US 12 Fort Atkinson EIS
Concept J Preliminary Environmental
Analysis and Alternatives Analysis

3575-09-01

**Technical
Memorandum**

Figure 1: Value Planning Concept J

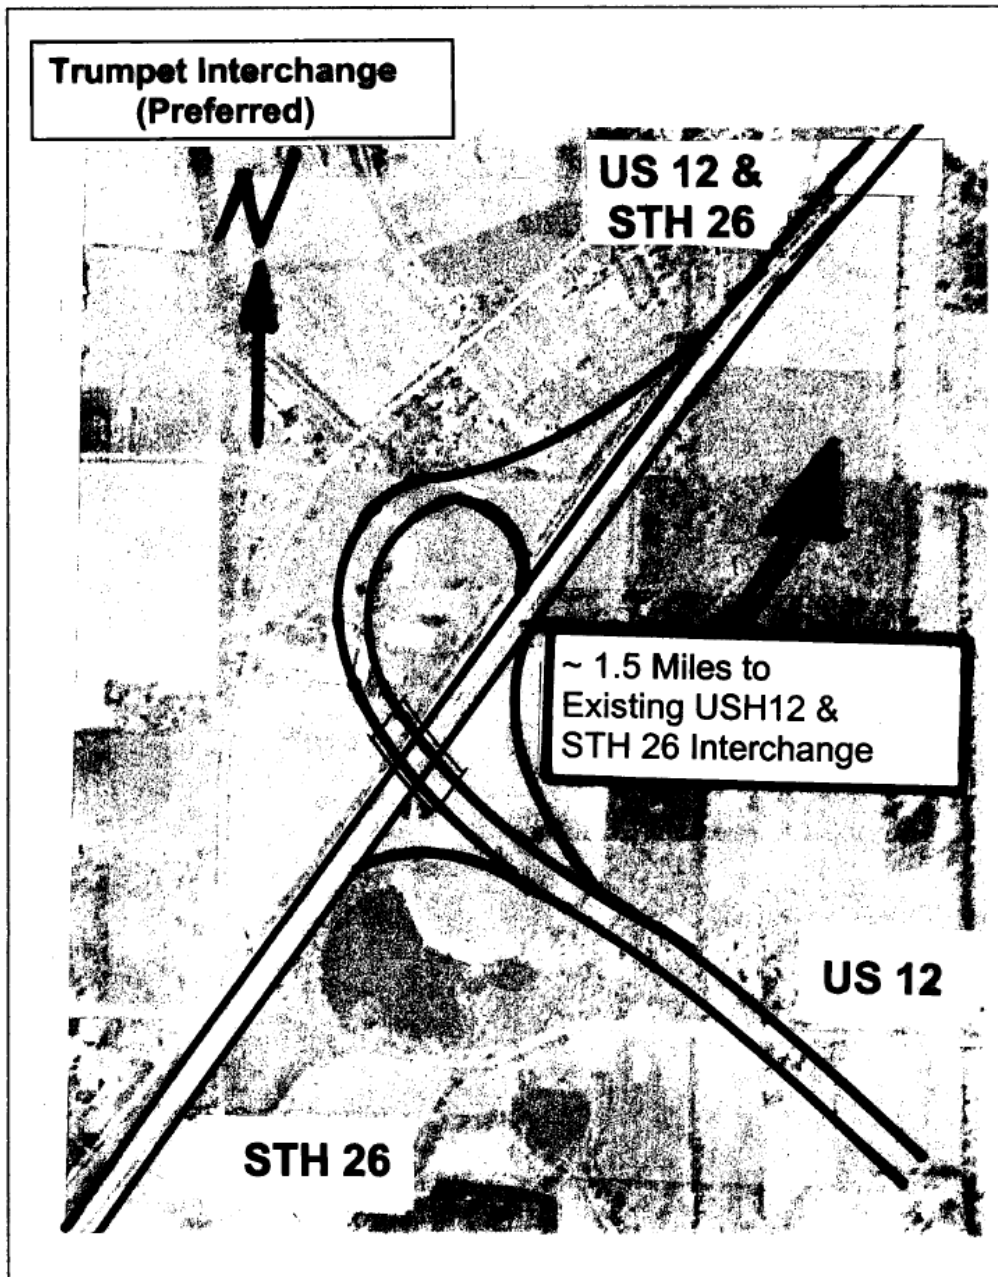
Concept J was recommended for analysis by the project’s Value Engineering study team as a possible alternative for the Fort Atkinson bypass. See Figure 1. Concept J is based on the Alternative 7a alignment, but proposes a different location and design of the US 12 bypass interchange at WIS 26. Concept J follows the alignment of Alternative 7a from the US 12 Bypass of Whitewater westerly to a point where it diverges on a more southerly alignment near the existing intersection of Creamery Road and McMillen Road. From there it continues west toward a proposed trumpet interchange located approximately one mile south of the existing WIS 26 and Business 26 interchange. See Figure 2.

The VE study team determined that Concept J held a number of advantages, one being that through traffic to and from Business 26 (Janesville Avenue) could be maintained on a more direct route rather than being routed through a separate diamond interchange at Commerce Parkway as is proposed in Alternatives 7 and 7a. Another Concept J advantage cited was lower right-of-way costs because the interchange would require less right-of-way than the interchanges proposed in Alternatives 7 and 7a. The VE study team acknowledged that they did not have adequate time or resources to verify real estate information. Indeed, subsequent analysis indicates that the location of the interchange would be over a platted residential subdivision.

As stated earlier, the VE study’s interchange and alignment drawing was cursorily prepared due to time limitations. So, for this analysis, HNTB sketched a preliminary design that more closely follows standard engineering requirements. This enabled a fair comparison of Concept J’s right of way requirements against the other bypass alternatives.

The proposed Concept J US 12/WIS 26 interchange loops were drawn with a 45 mph design speed and the ramps have a 55 mph design speed. In addition, the study did not have sufficient time to analyze local road access impacts. The primary impact is that the jug-handle interchange being built in a few years as part of the WIS 26 4-lane expansion is incompatible with the Alternative J/WIS 26 interchange. Moving the Concept J trumpet interchange far enough north to avoid that jug-handle was not an option. This would have reduced the spacing between the Concept J trumpet and the existing WIS 26/Business 26 trumpet interchange to under 1/2-mile. To address this, a new service interchange was added to Concept J at Pond Road a mile or so east of WIS 26. This interchange was not accounted for in the VE Study.

Figure 2: US 12 Fort Atkinson Bypass Alternatives

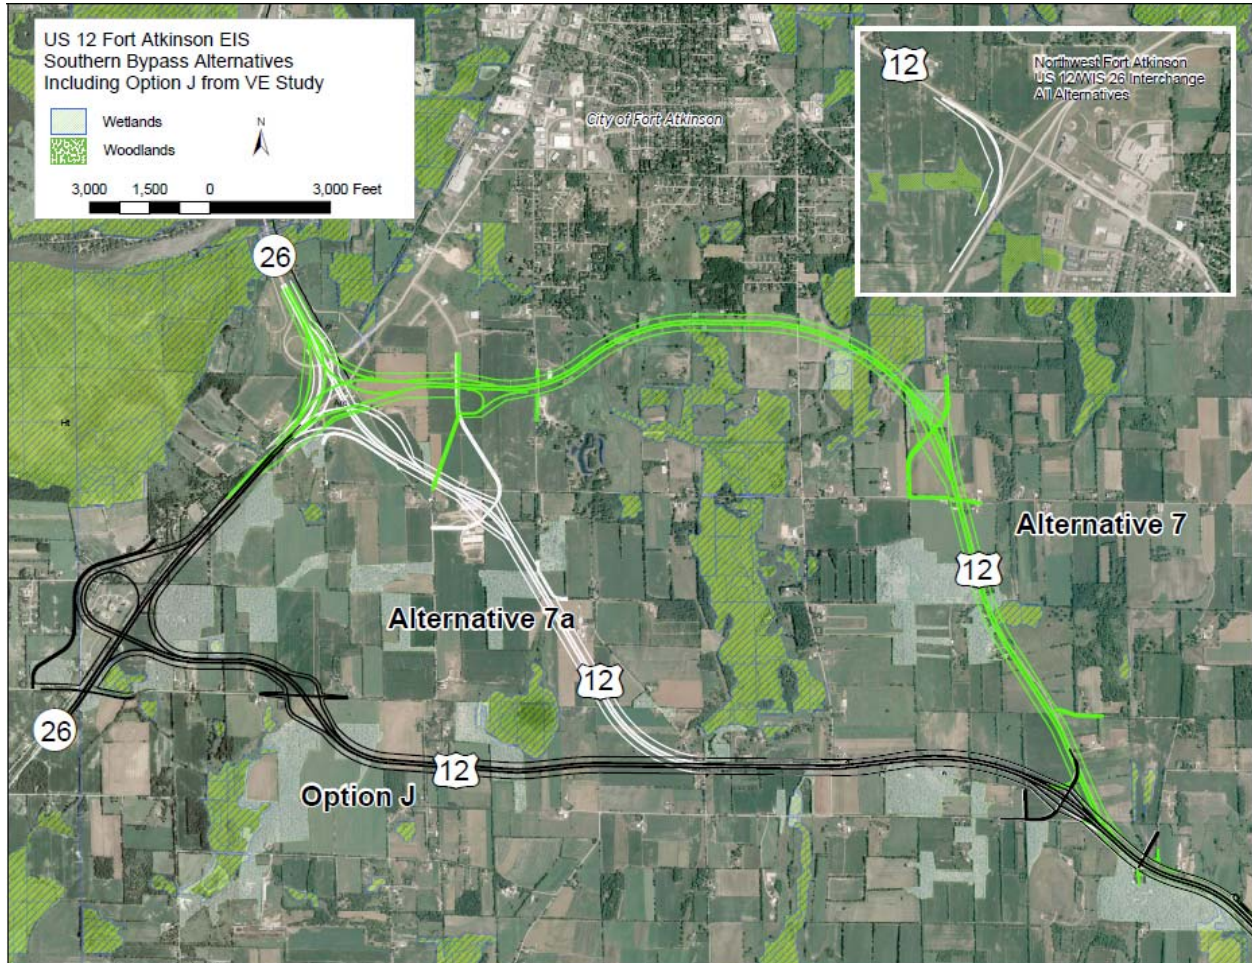
A comparison of the bypass alternatives was made applying the same initial screening criteria to Concept J as was applied to each of the alternatives in the DEIS. Given that the VE study team did not have sufficient time to lay out their proposed Concept J interchange, the probable footprint was estimated as shown in Figure 1. Subsequently, HNTB developed a preliminary design for the Concept J interchange and mainline using WisDOT design standards. The corridor width used for this impact analysis equaled the corridor width used for the bypass alternatives in the Draft Environmental Impact Statement (DEIS). This 400 foot wide corridor is shown in

Figure 2. Table 1 summarizes the potential impacts within the study corridor and is formatted similar to the “Impacts Summary Chart” that is found in the DEIS. Natural resource impacts of Alternatives 7 and 7a were updated using newer aerial photographs than were available for the DEIS, providing a fair comparison of all three bypass alternatives.

The one-mile spacing between Concept J’s proposed trumpet interchange at US 12 and WIS 26 and the existing WIS 26 and Business 26 interchange is a minimum standard distance, however, traffic safety and operations would likely become a concern as traffic volumes increase in the future. By year 2035, merge and weave conflicts could be expected. Additional auxiliary lanes would help alleviate this problem, but would require additional investment in the WIS 26/Bus. 26 interchange.

Also, the Pond Road service interchange on the Concept J alignment has less than desirable design features. The skewed angle of the Pond Road crossing at the interchange with US 12 is greater than the desirable maximum. Two horizontal curves had to be added on the US 12 mainline alignment to create this skew. Ramp merges and diverges occur within these curves. The Pond Road interchange is also too close to the system interchange to the west. Placement of this interchange an adequate distance from the trumpet interchange will not be possible without impacting additional wetlands. When added together, they compromise the safety of the Concept J.

Figure 3: Subdivision at the trumpet interchange of Concept J

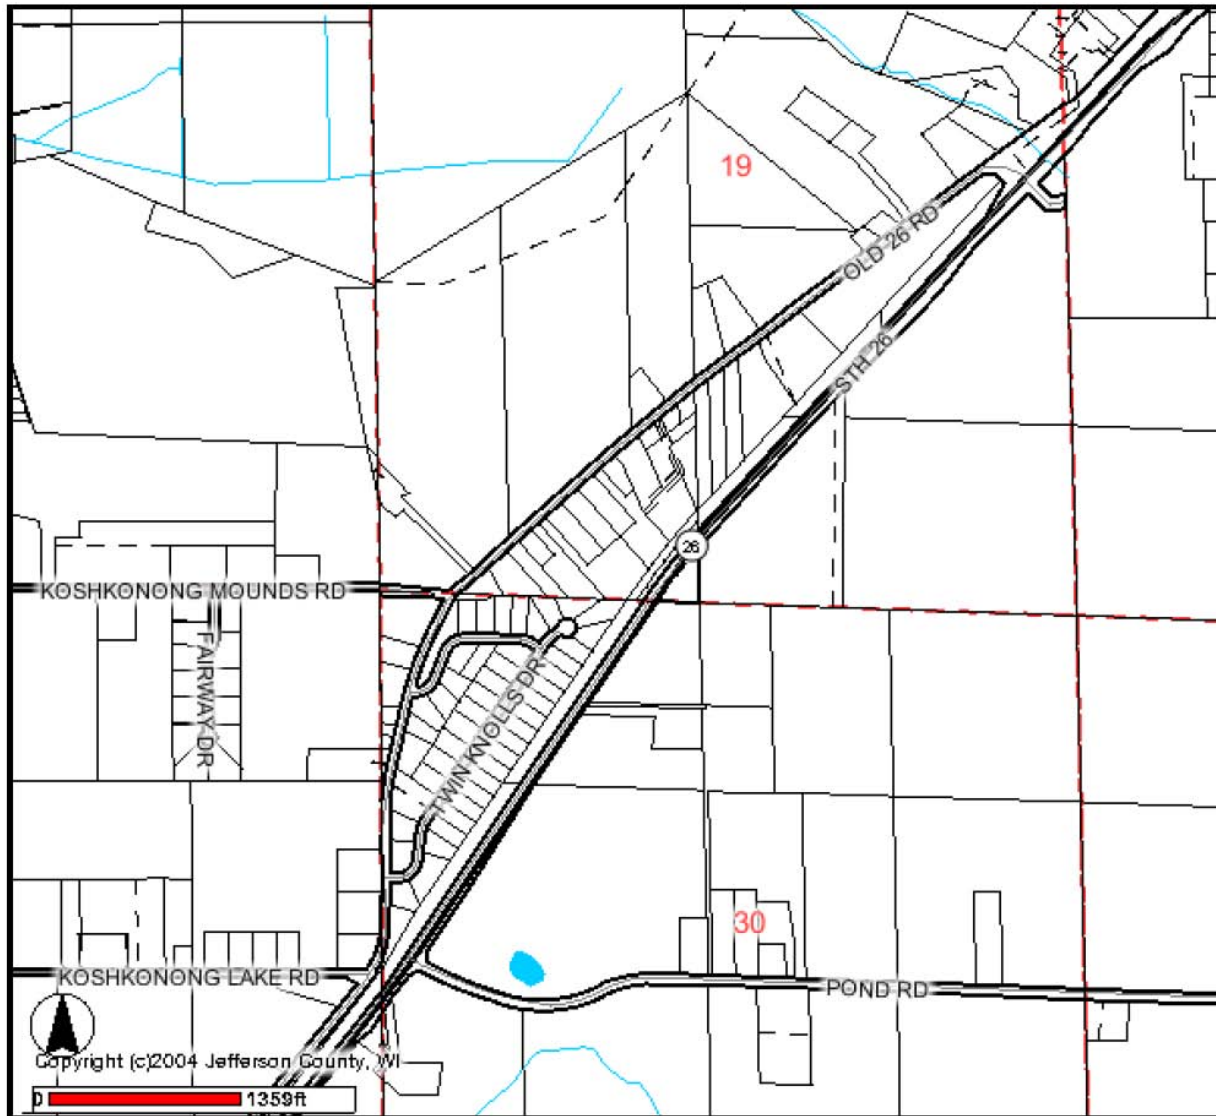
HNTB tallied the number of residential units that are within the 400 foot wide study corridor. The WIS26/US 12 interchange of Concept J is located on top of a relatively recent residential

subdivision. Multiple homes have been constructed in the footprint of the Concept J interchange and there are still a number of vacant lots available for future construction. Preliminary analysis indicates that 81 units are currently in the Concept J study corridor, of which about 20 are currently vacant lots within the subdivision on WIS 26. See Figure 3. The 81 units that would be affected by Concept J would be far greater than Alternative 7, which would affect 32 units, and Alternative 7a, which would affect 25 units.

Acquisition and relocation of the large number of homes within the Concept J interchange footprint as well as residences along the mainline would be significantly more costly than originally anticipated by the VE Study team. To get an idea of the value of this property, HNTB analyzed the “estimated fair market values” provided online at Jefferson County’s GIS website on 12/20/07. From these numbers one can estimate that the current value of the residential lots within the interchange area is about \$7.46 million. Considering the average value of the lots currently built on is over \$215,000, the value of the lots when they are built out could top \$12 million, in today’s dollars.
